Appendix A
Responses-to-comments Table

**Section 16 Planning Application for Proposed Commercial Use at Phase IIa Development of an Approved Master Layout Plan (MLP) with Minor Relaxation of Plot Ratio Restriction (Proposed Amendments to the Approved MLP for Comprehensive Residential, Commercial, Social Welfare Facility and Public Vehicle Park Development; with Minor Relaxation of Plot Ratio Restriction Approved at Phase III) at Lot Nos. 461 RP, 462 S.B, 463 S.B, 464 RP, 495 RP and 539 S.B in D.D. 116, Yuen Long Town Lot (Y.L.T.L.) 504, Y.L.T.L. 544 (Part) and Adjoining Government Land, Yuen Long, New Territories
(Application No. A/YL/333)**

Attachment 3

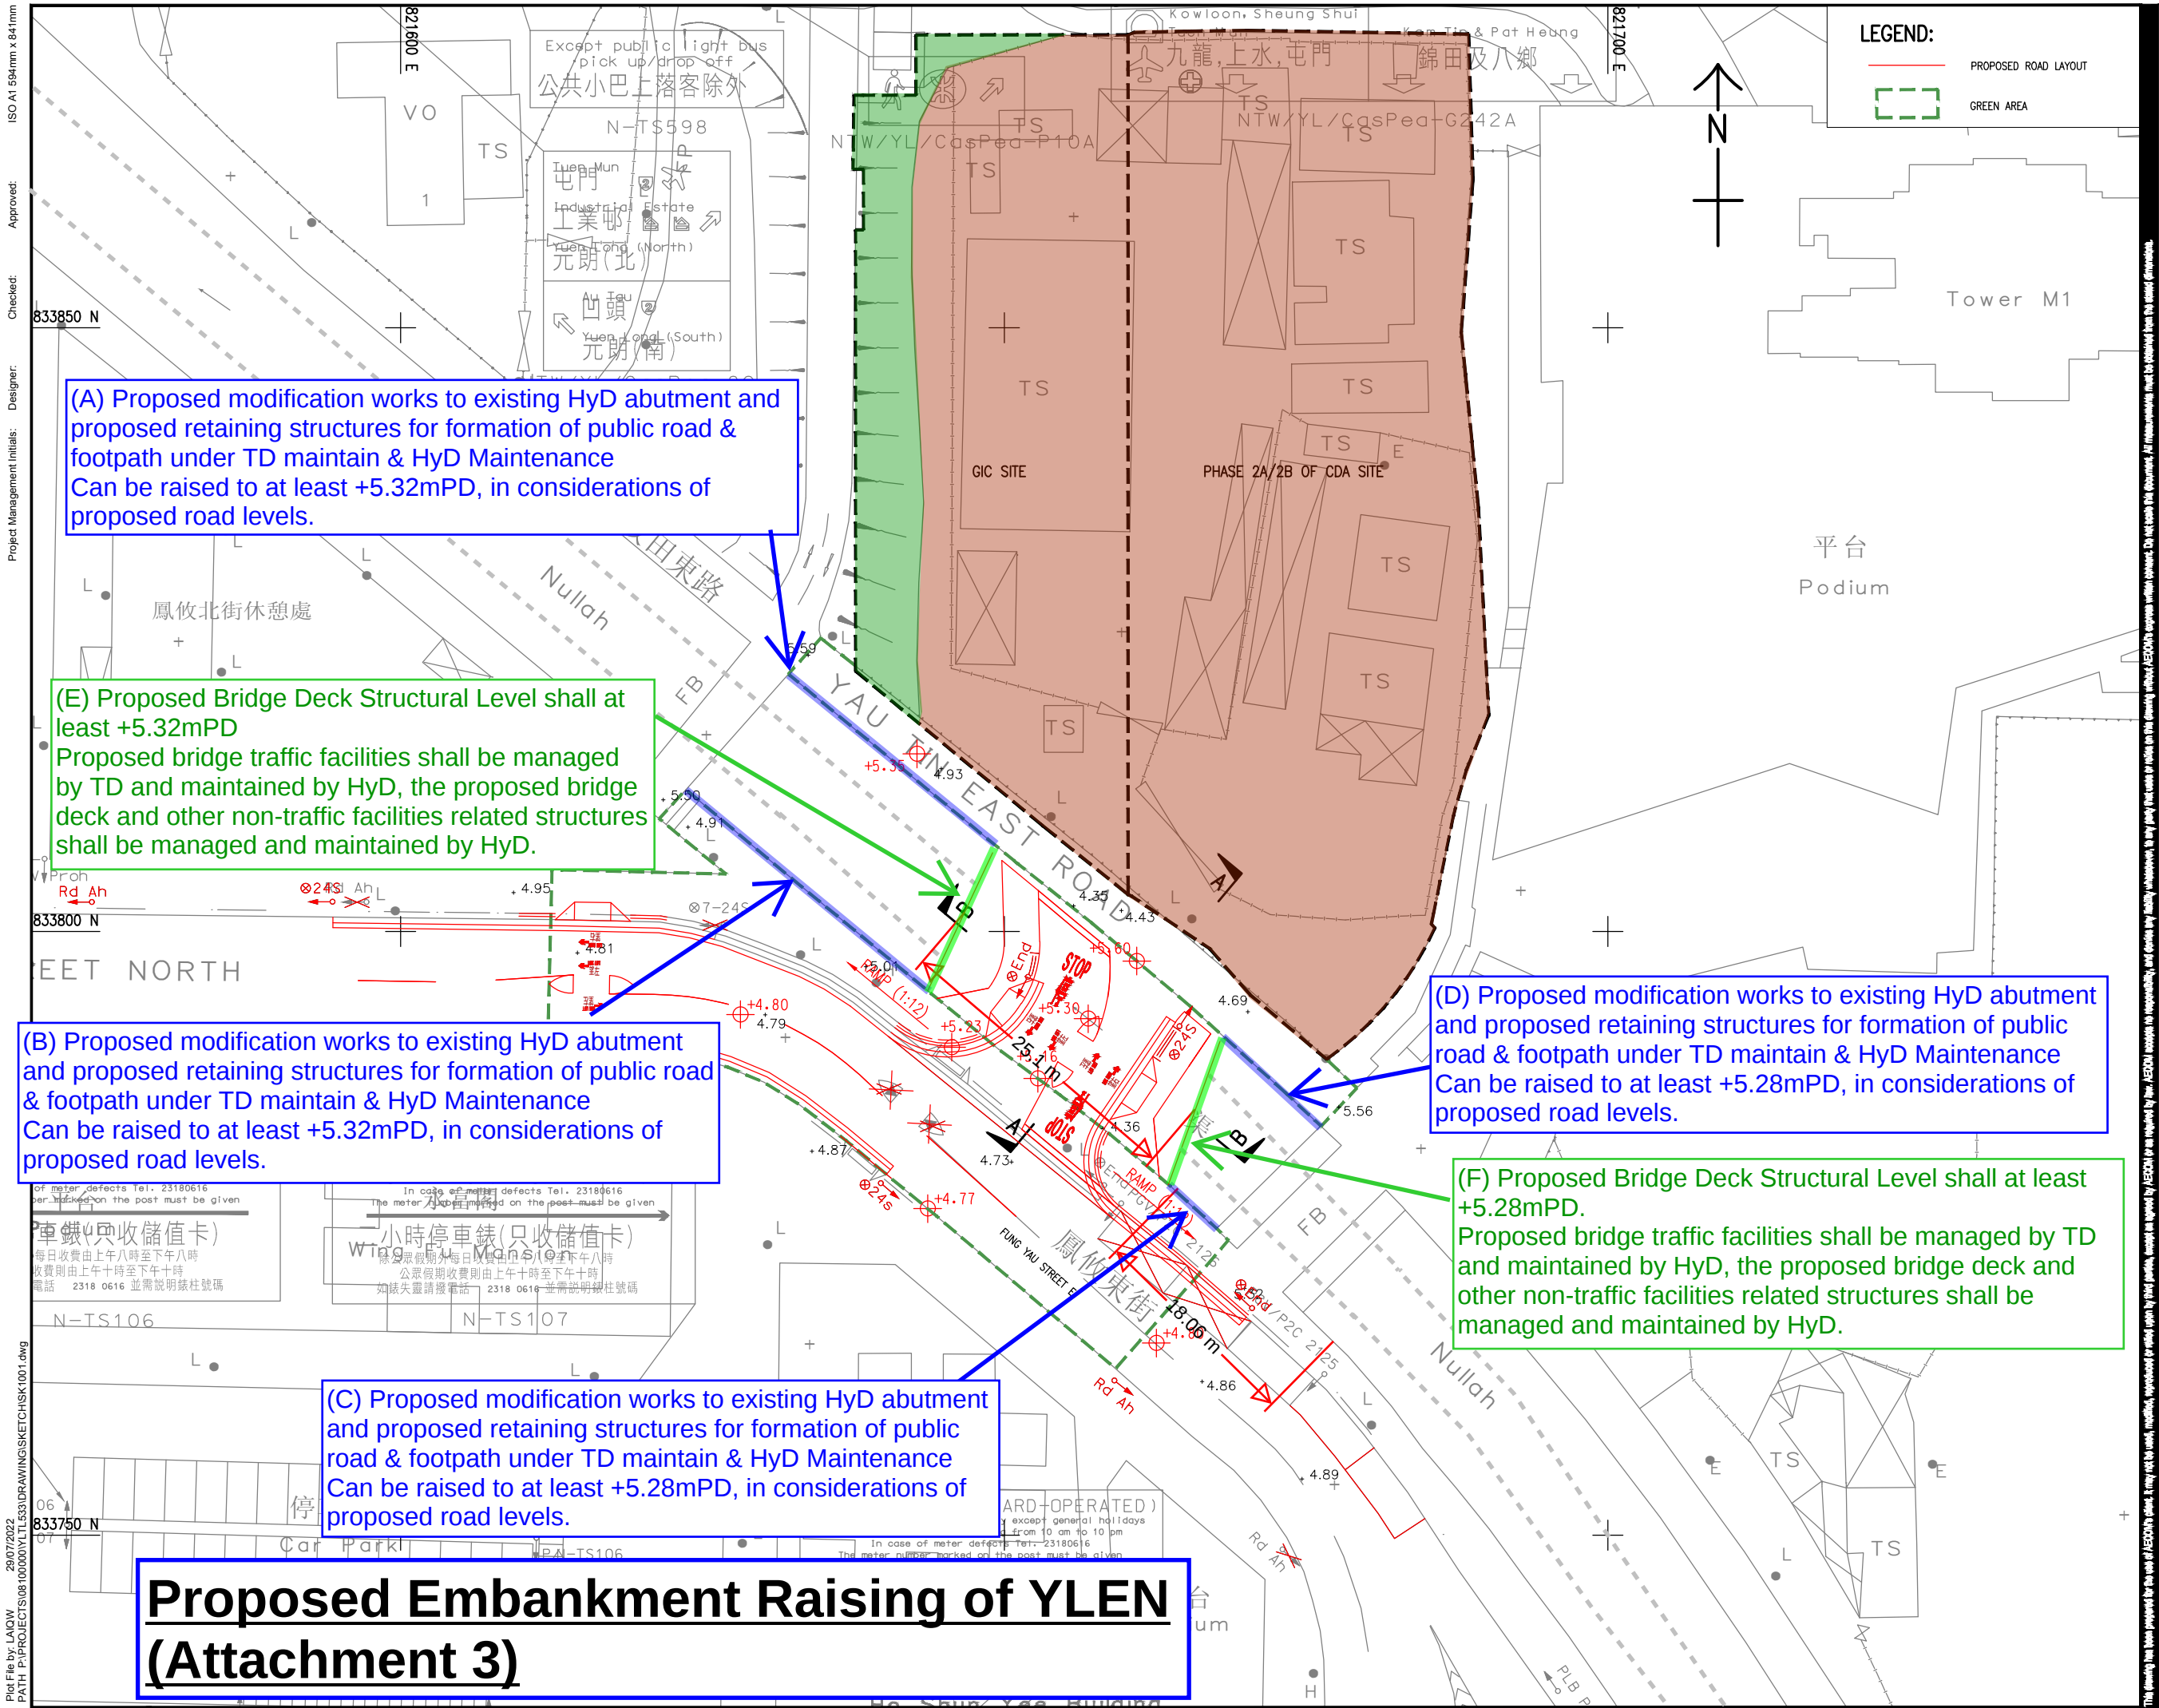
Scenario		Maximum Water Level	Minimum Bridge Soffit Level	Mitigation Measures;
#1	➤ Before construction bridge deck; and ➤ Before Yuen Long Barrage scheme	4.626 mPD	<NIL, Pre-development Stage>	
#2	➤ After construction bridge deck; and ➤ Before Yuen Long Barrage scheme	4.656mPD	4.262mPD	Raise the YLEN embankment height to at least +5.28mPD (Layout as shown in Attachment 3)
#3	➤ After construction bridge deck; and ➤ After Yuen Long Barrage scheme	3.863mPD	4.262mPD	Raise the YLEN embankment height to > +5.28mPD (Layout as shown in Attachment 3)

As mitigation measure, a minimum embankment level of 5.28mPD (i.e. > 300mm freeboard) along the concerned section of YLEN is suggested to be provided (i.e. > 300mm freeboard), please refer to Attachment 3 for the layout of the proposed measures.
